**San Diego County Regional Airport Authority (SDCRAA)
Flight Procedure Evaluation
Citizen Advisory Committee Meeting #2**

San Diego International Airport

July 19, 2018

DRAFT Deliberative Document – For Discussion Purposes Only

ANAC Noise Recommendation 15 – Night Alt 2

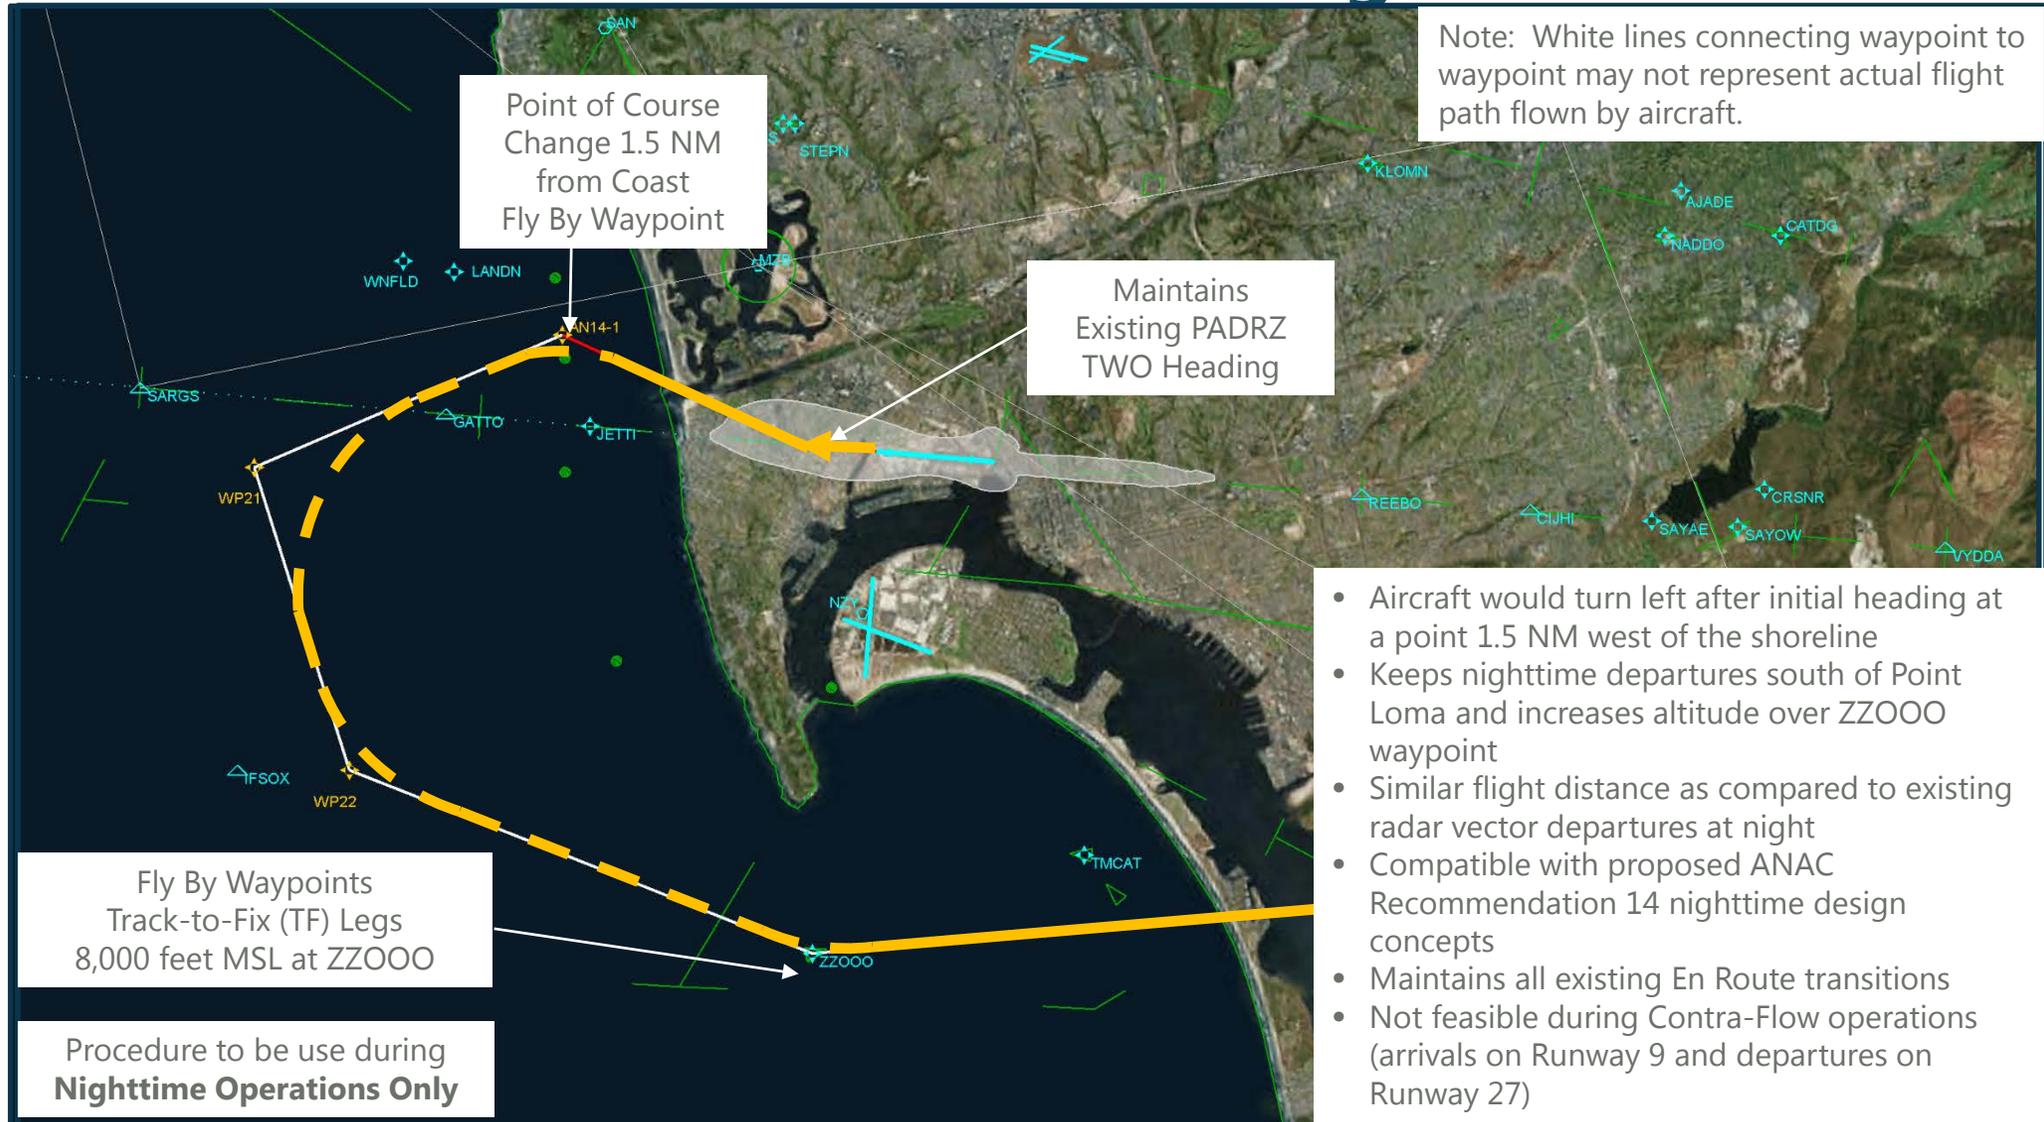
- Night Alternative 2
 - Provides a more consistent flight track
 - Does not help mitigate noise over Mission Beach
- Night Alternative 3
 - Turn radius following JETTI will vary more as compared today if 230kt speed restriction is eliminated

- CAC: Alternative 2 – This does not help mitigate noise over Mission Beach

ANAC Noise Recommendation 16 – Alt 2

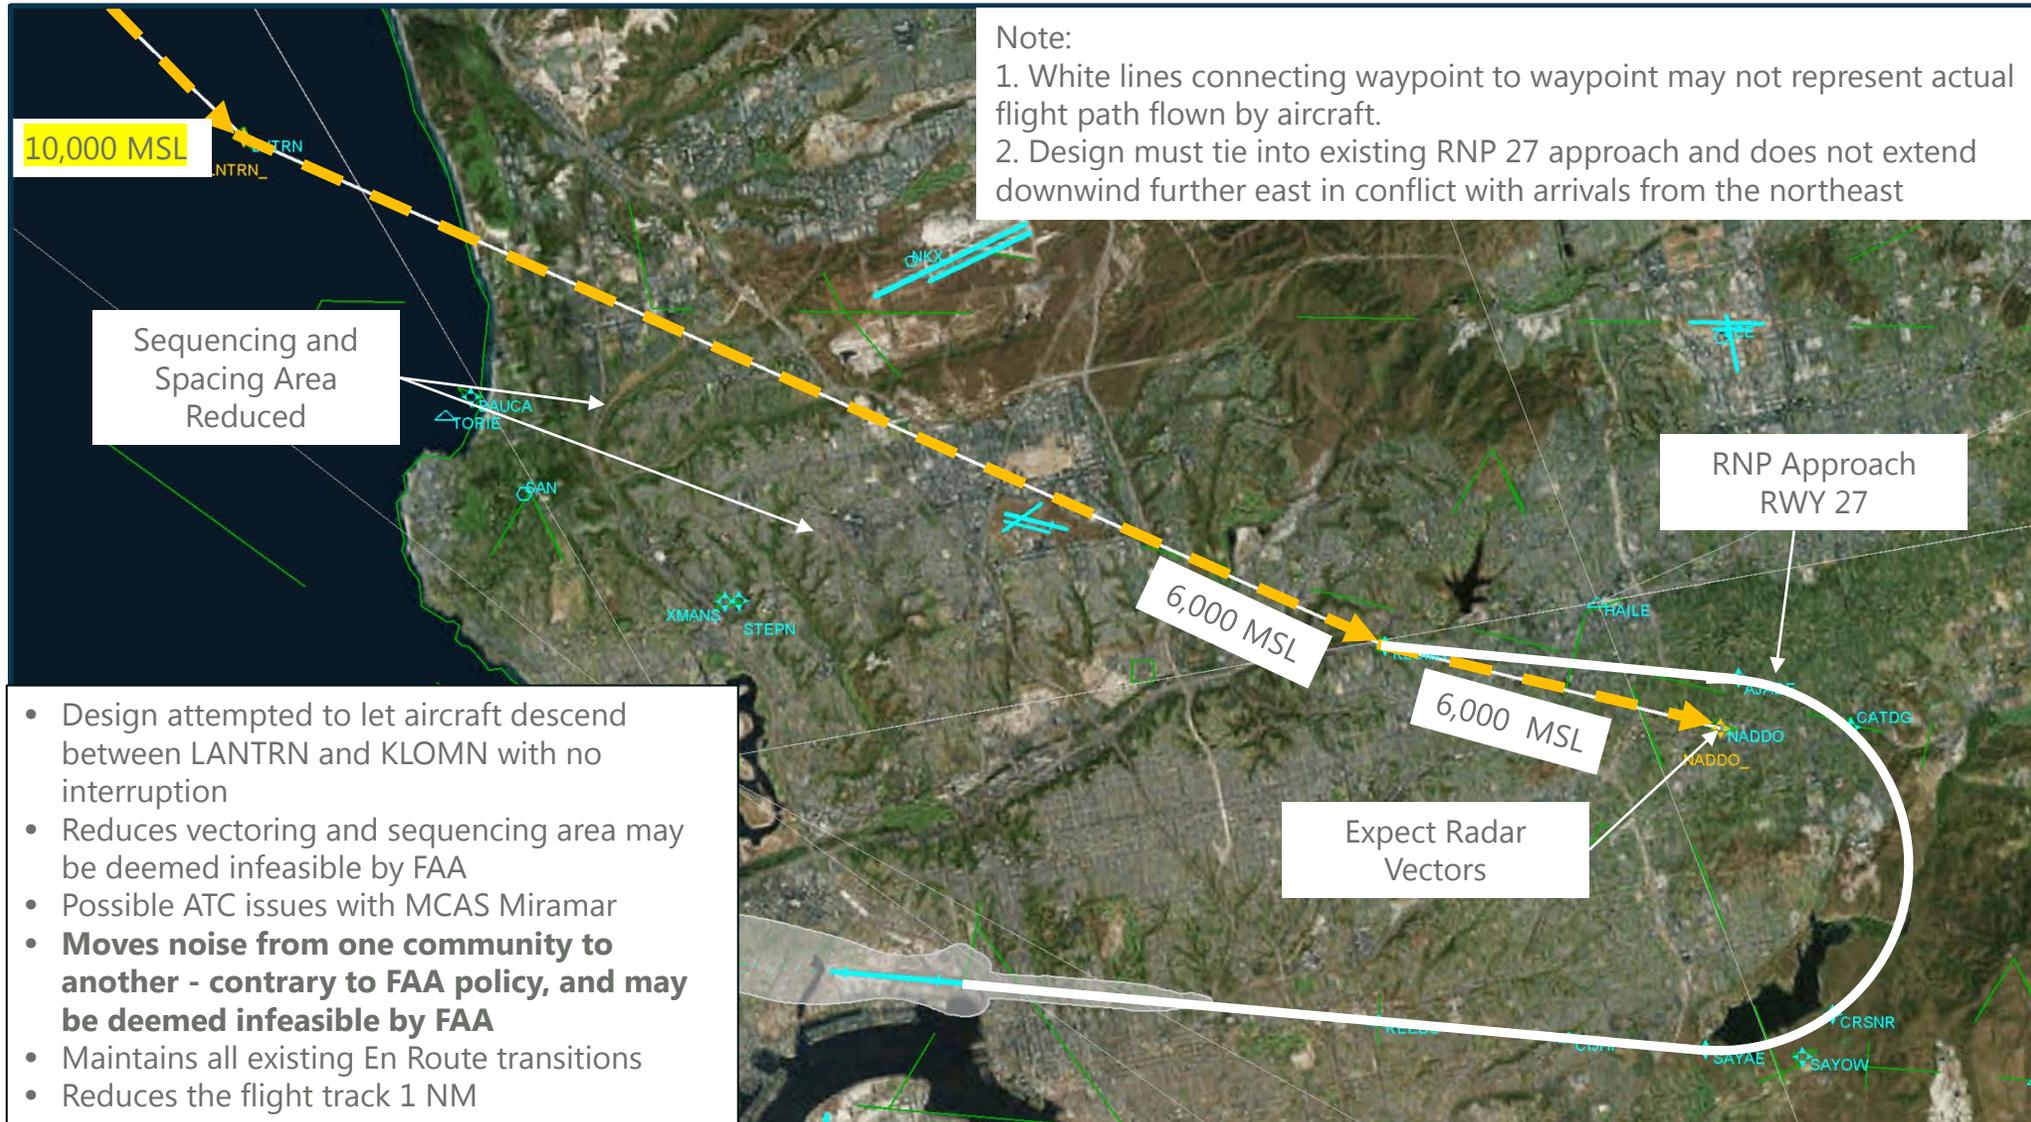
■ Alternative 2

- KLOMN at 6,000 feet is difficult to make for the navigation software. Steep descents are not recommended with speed reductions in arrival procedures. This combination could lead some navigation software to reduce speed well before air traffic control would like the aircraft to be at a slower speed.
- Reference to historic flight tracks related to moving COMIX arrivals north.

ANAC Noise Recommendation 16 – Alt 3

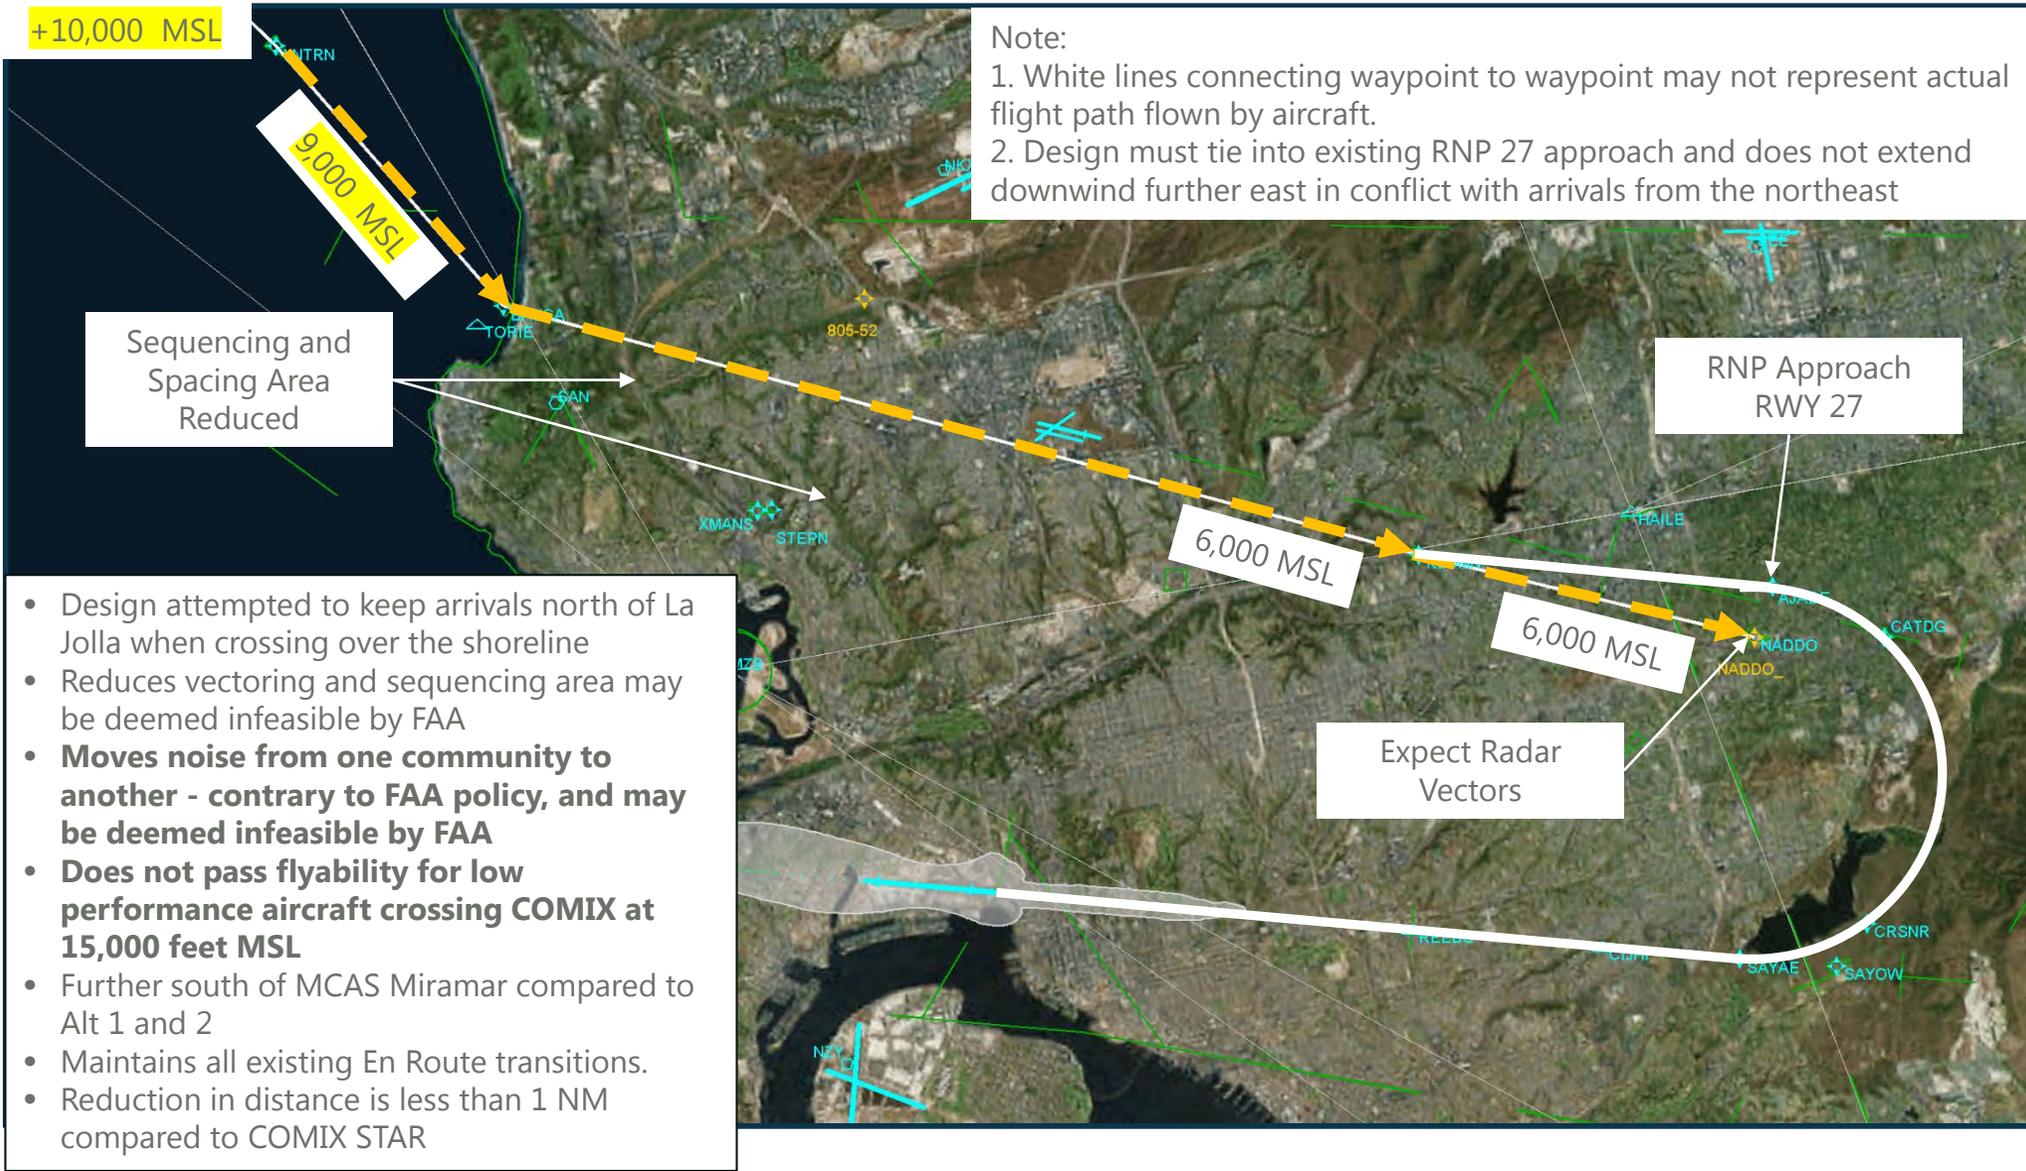
- Design attempted to keep arrivals north of La Jolla when crossing over the shoreline
- Reduces vectoring and sequencing area may be deemed infeasible by FAA
- **Moves noise from one community to another - contrary to FAA policy, and may be deemed infeasible by FAA**
- **Does not pass flyability for low performance aircraft crossing COMIX at 15,000 feet MSL**
- Further south of MCAS Miramar compared to Alt 1 and 2
- Maintains all existing En Route transitions.
- Reduction in distance is less than 1 NM compared to COMIX STAR

- Alternative 3

- KLOMN at 6,000 feet is difficult to make for the navigation software. Steep descents are not recommended with speed reductions in arrival procedures. This combination could lead some navigation software to reduce speed well before air traffic control would like the aircraft to be at a slower speed.
- Not preferred due to lower altitude crossing coastline, worse impact on La Jolla, and does not meet recommendation.
